NOTICE OF MEETING
PLANNING AND ZONING COMMISSION
6:00 P.M. – October 13, 2022
30360 Cougar Bend, Bulverde, TX 78163

PLANNING AND ZONING COMMISSION ITEM:
PC-21-08
FINAL PLAT
SPRING BRANCH VET HOSPITAL

PLANNING AND ZONING COMMISSION ITEM:
PC-22-30
FINAL PLAT
Heimer Cove

PLANNING AND ZONING COMMISSION ITEM:
PC-22-31
FINAL PLAT
4S RANCH UNIT 8B

PLAT ESTABLISHING SPRING BRANCH VET SUBDIVISION

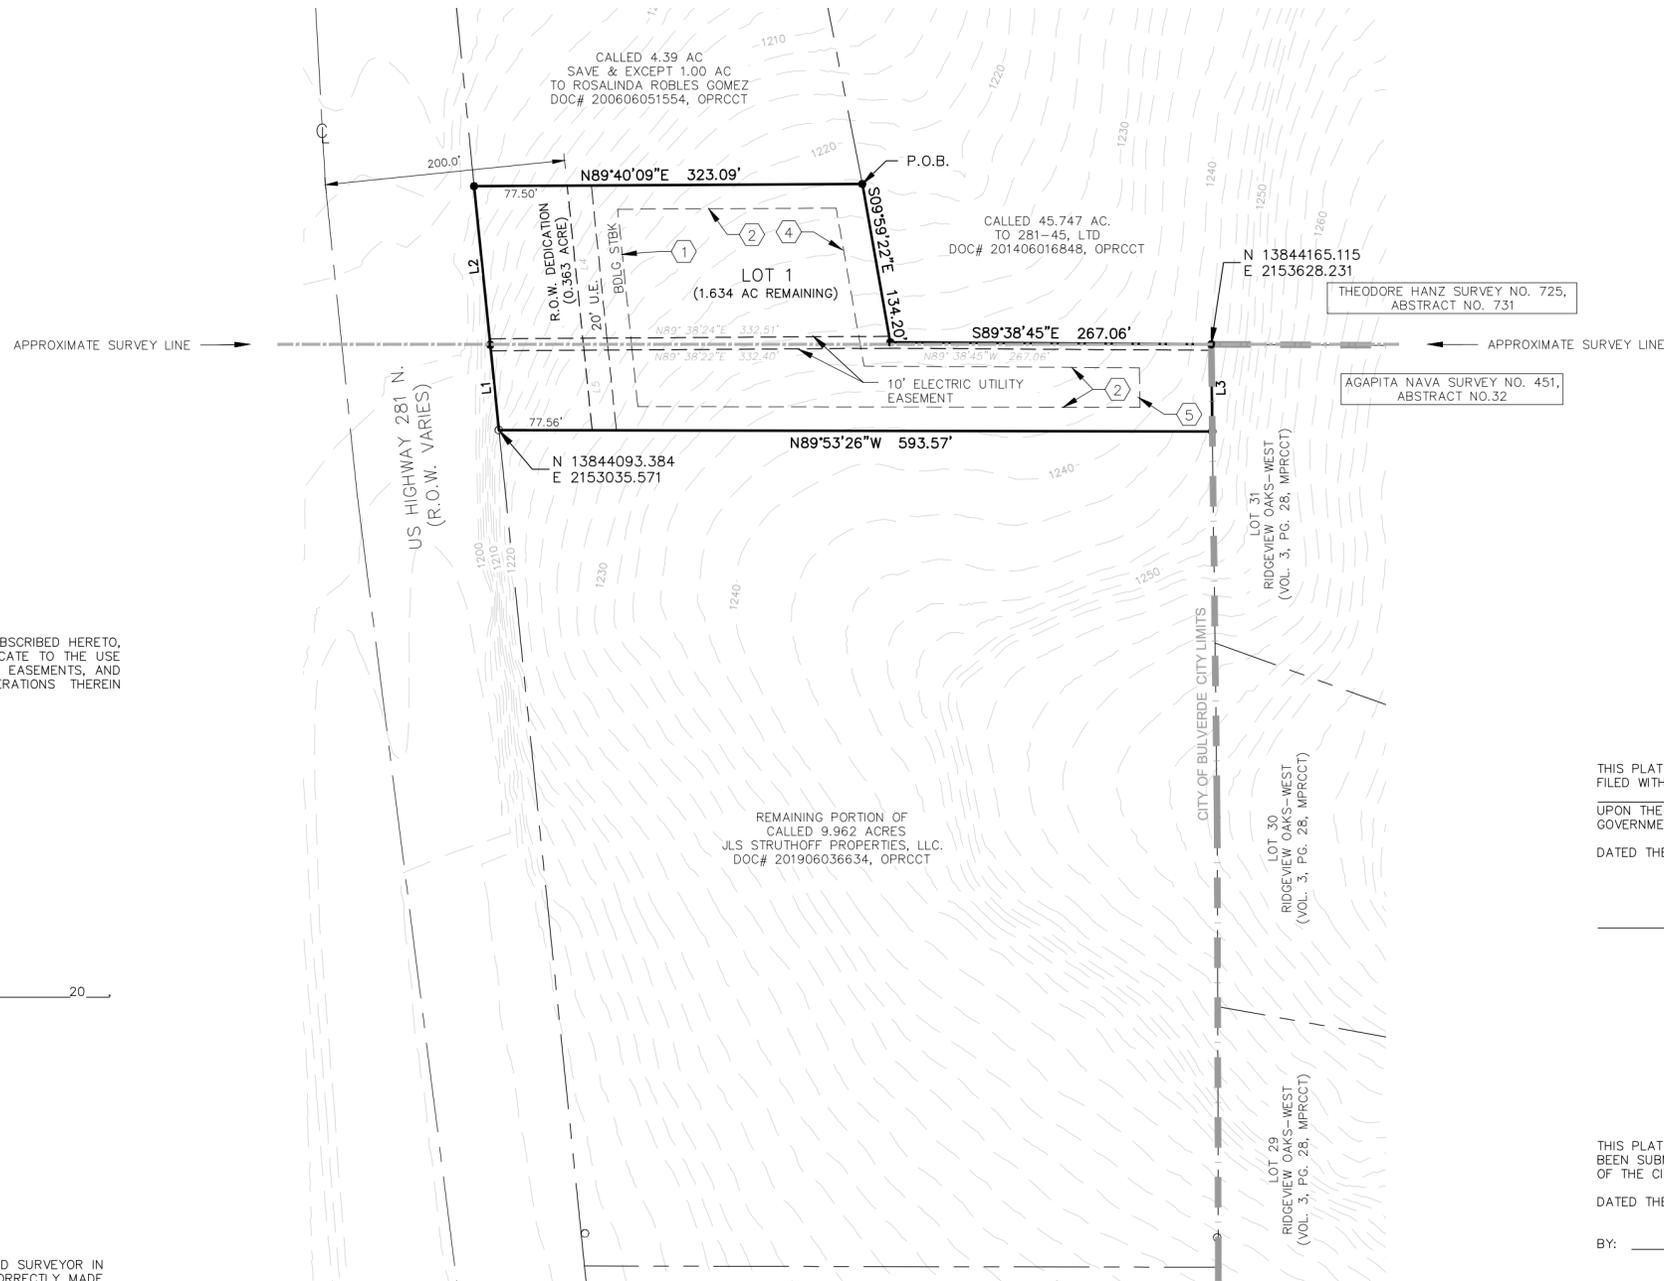
1. Bearing and distance dimension from a corner of the subdivision to a corner of the original tract or original survey. – [Comment resolved](#)
2. A minimum of two corners of the subdivision referenced to State Plane Grid Coordinates. – [Comment resolved](#)

3. Contour lines showing existing elevations at a two-foot contour interval for slopes up to 10 percent and at a five-foot contour interval for slopes greater than 10 percent. Contour lines shall be gray-scaled to avoid confusion with the subdivision lot lines, right-of-way boundaries, etc. – [Comment resolved](#)

4. Label all easements with bearing and direction to a fixed location. – [Comment resolved](#)
5. Provide bearing, direction and acreage of ROW “dedication”. – [Comment resolved](#)

6. Missing setback lines and legend with abbreviations and line types (place front setback line behind the ROW dedication). – [Comment resolved](#)
7. Plat does not close, see closure check below. Make sure bearing & distance is directed in a clockwise direction around the perimeter for closure. – [Comment resolved](#)

8. Remove the signature block for the City Engineer. – [Comment resolved](#)

10. Remove note 6 regarding the proposed use of the subdivision. – [Comment resolved](#)
11. Removed note 8 regarding elevations. – [Comment resolved](#)
12. Provide the name and address of the Lienholder. – [Comment resolved](#)
13. State building setback line dimensions on the plat. – [Comment resolved](#)
14. Add P&Z signature block as stated below. – [Comment resolved](#)

15. Verify all signature block dates are updated to 2022 or left as 20__ (notary block and planning director block are out of date). – [Comment resolved](#)
16. Lot acreage should be called out reflecting the acreage after proposed right-of-way dedication. – [Comment resolved](#)
17. Provide proof of TxDOT approval. – [Comment resolved](#)

18. According to the Drainage Report, dated 3/16/21, proposed improvements are limited to just over 3,000 SF of additional parking area. The existing lot already includes 30,000 SF of impervious cover from concrete driveway, parking lot and 4,000 SF building. Runoff will follow existing grade to a well-defined drainage ditch along US-281 and drain north for 200 LF before entering an existing drop inlet. Half concurs that the additional runoff generated from this development should not adversely affect adjacent properties and is adequately safe from flooding. – [no response required](#).

approved if it results in a remainder tract that cannot be legally platted under the terms of the Bulverde Code of Ordinances. – *response says there should be no legal reason that the remaining 9.962 acres could not be platted independently, but this does not comply with Section 1.06(e)(i)(2) of the Subdivision Ordinance: A remainder tract shall not be considered in compliance with this Ordinance, unless:*

The remainder tract will need to be platted concurrently. [Comment resolved.](#)

BEING A 8.962 OF AN ACRE TRACT OF THE AGAPITA NAVA SURVEY NO. 451, ABSTRACT NO. 32, IN COMAL COUNTY, TEXAS, BEING OUT OF A CALLED 9.962 ACRE TRACT OF LAND, AS CONVEYED TO JLS STRUTHOFF HOLDINGS, LLC, AND RECORDED IN DOCUMENT NO. 201906036634, OF THE OFFICIAL PUBLIC RECORDS OF COMAL COUNTY, TEXAS.

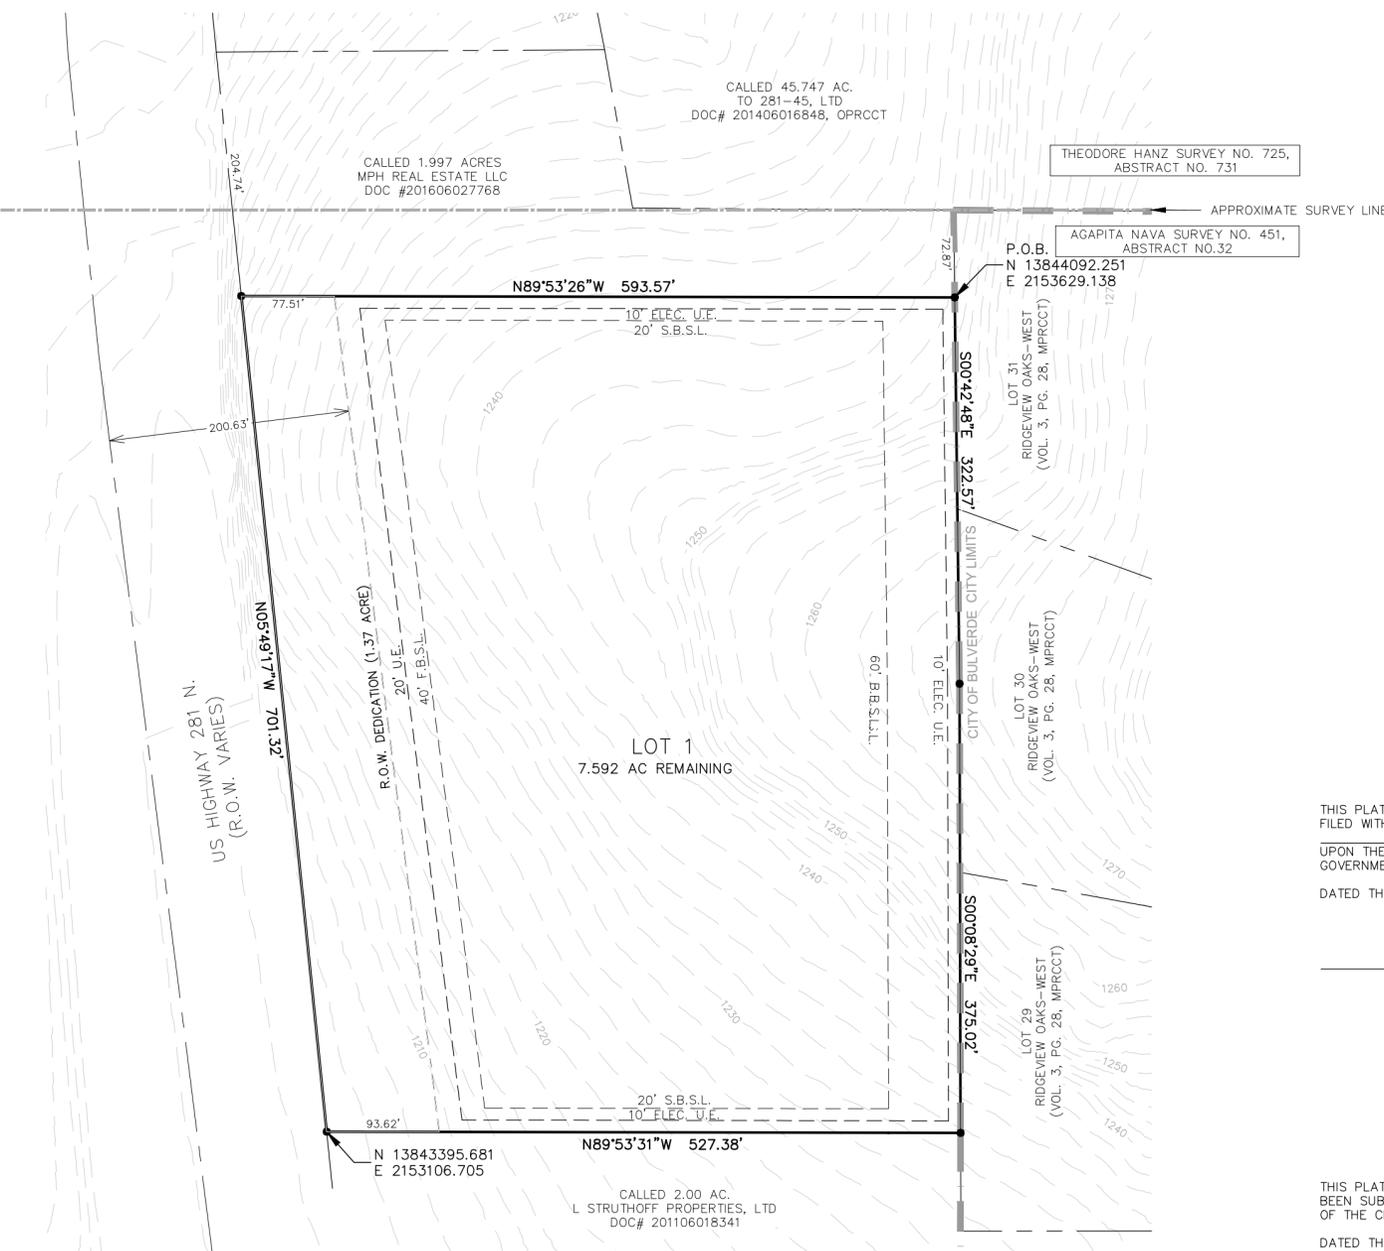
1. Provide a bearing and distance dimension from a corner of the subdivision to a corner of the original tract or original survey. **Comment resolved.**
2. A minimum of two corners of the subdivision referenced to State Plane Grid Coordinates. **Comment resolved.**
3. Provide a dimension from the current property line to the proposed right of way dedication line. **Comment resolved.**
4. Lot acreage should be called out reflecting the acreage after proposed right-of-way dedication. **Comment resolved.**
5. Conveyance plat shall include the Acknowledgement stated in Section 1.05(k)(viii): **Comment resolved.**

6. Add P&Z signature block as stated below. **Comment resolved.**

7. Verify all signature block dates are updated to 2022 or left as 20__ (notary block and planning director block are out of date). [Comment resolved.](#)
8. Provide proof of TxDOT approval. [TxDOT approval/email correspondence provided.](#)

FINAL PLAT
ESTABLISHING
HEIMER COVE UNIT 1

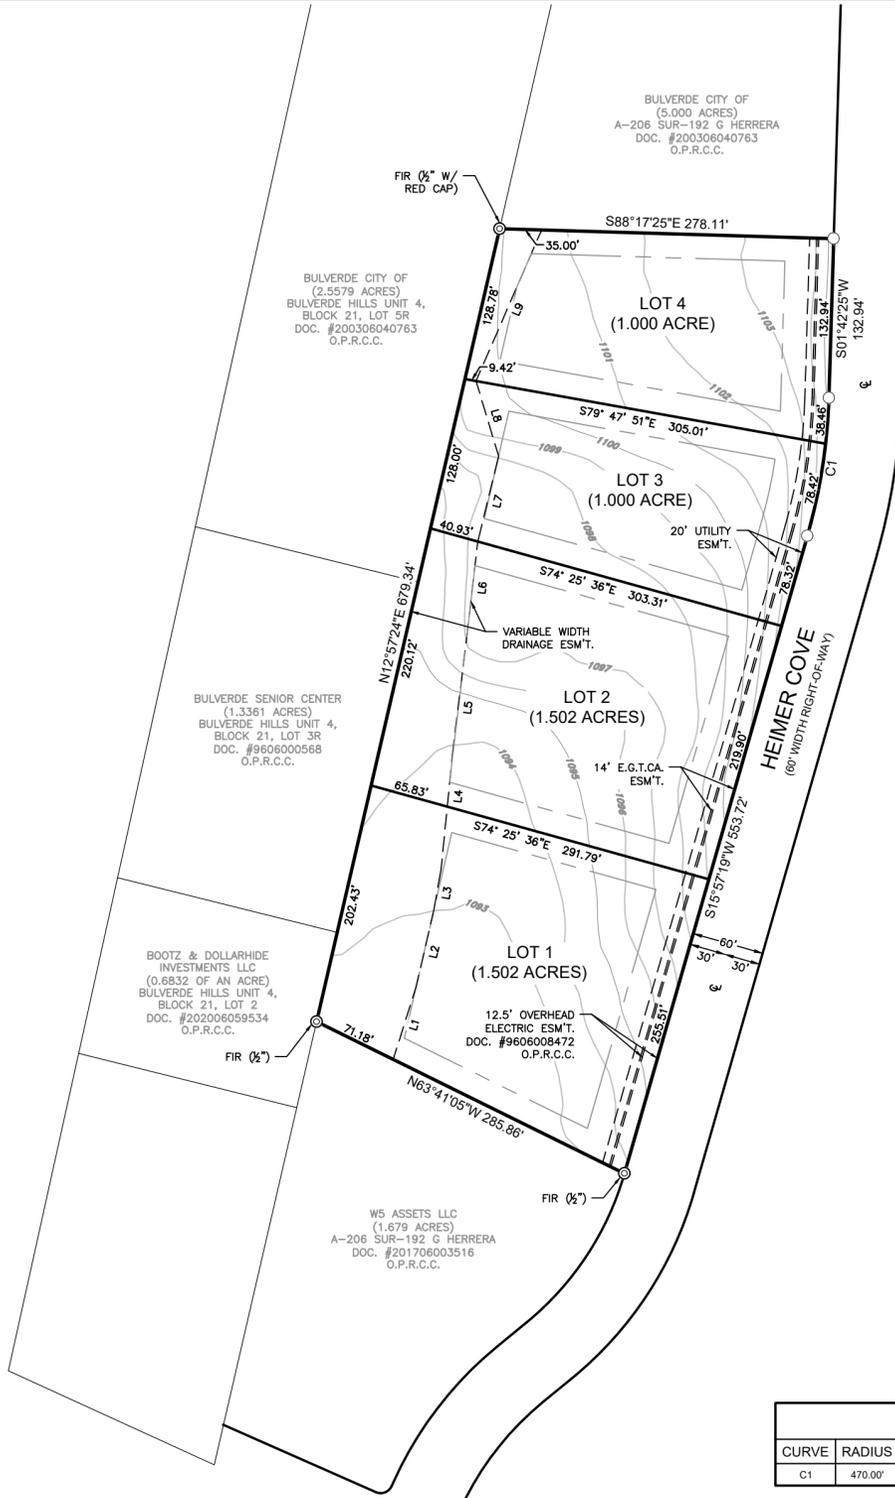
1. (12) Block number required for all lots.
2. (14) Provide a bearing and distance dimension from a corner of the subdivision to a corner of the original tract or survey.
3. (15) Provide state plane grid coordinates for a minimum of 2 property corners.
4. (18) Add note referencing vertical control datum of contours.
5. (19) Add note referencing FEMA floodplain for the subject property.
6. (20) Use light dashed lines for features not within the boundary of the subdivision.
7. (24) Provide a slope map prepared under section 4.02. Include plat notes required by that section if slope easements apply.
8. Add Planning Director signature block as stated below.

9. Provide notes on the plat regarding the provider for each utility service for the proposed lots.
10. Reference comment #20 below regarding riparian buffer and drainage easement.

11. (d) Add note regarding septic service to Final Utility Layout.
12. (e) Include a schematic site plan show basis for TIA worksheet calculations.

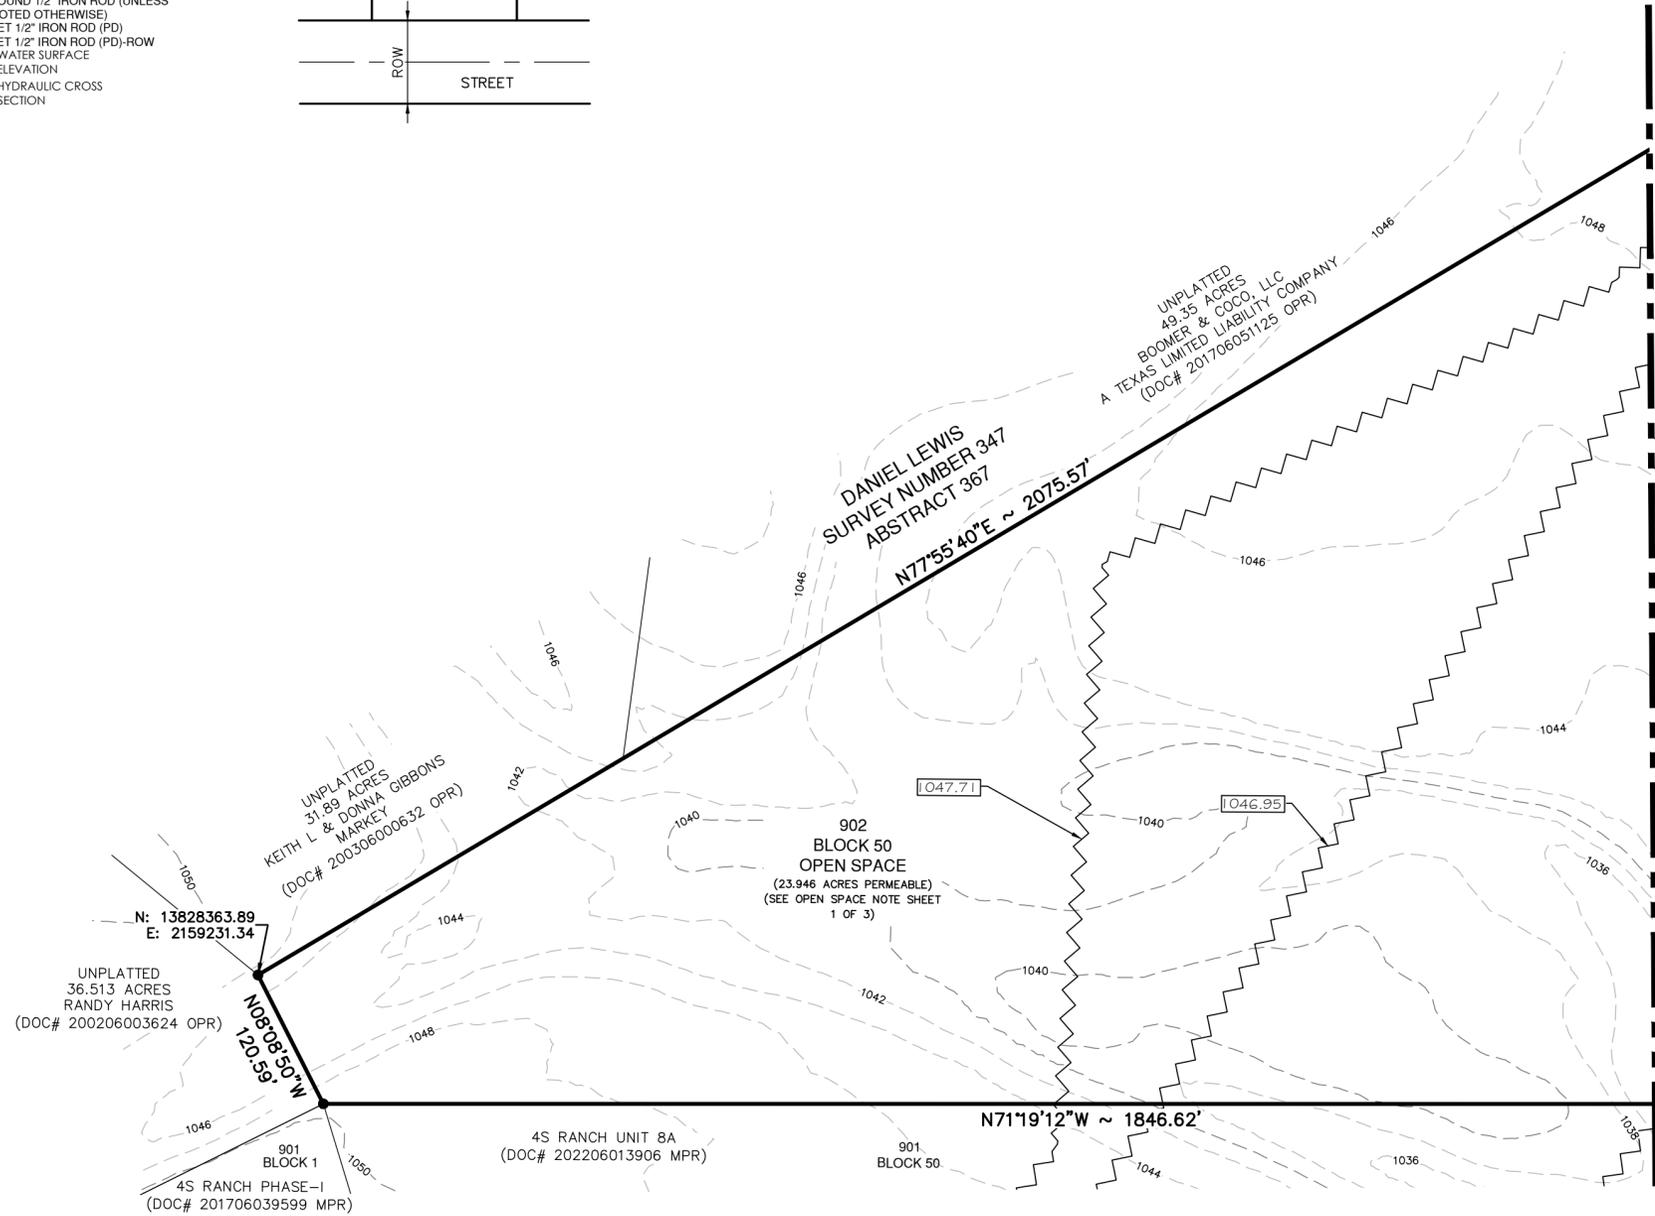
1. Provide updated status of LOMR approval by FEMA and update floodplain note if applicable.
Comment resolved.

1. (ii)(f) Cost Estimate do not match the submitted LOC documents. **Updated LOC required prior to Final Plat recordation.**
2. (ii)(o) Deed restrictions or homeowner association documents required with final plat application.
Comment resolved.
3. (ii)(s) Lienholder's acknowledgement of plat recordation required. Deed shows two liens (Texas Community Bank & 633-4S Ranch, LTD/Stahl Lane, LTD). **Comment resolved.**
4. 1.04(e)(iii) Preliminary plat for this project was approved on December 28, 2020, and expires after 12 months if a final plat has not been filed. Extension needs to be submitted for approval by City Council. **Request for extension received. City staff to process for City Council consideration.**
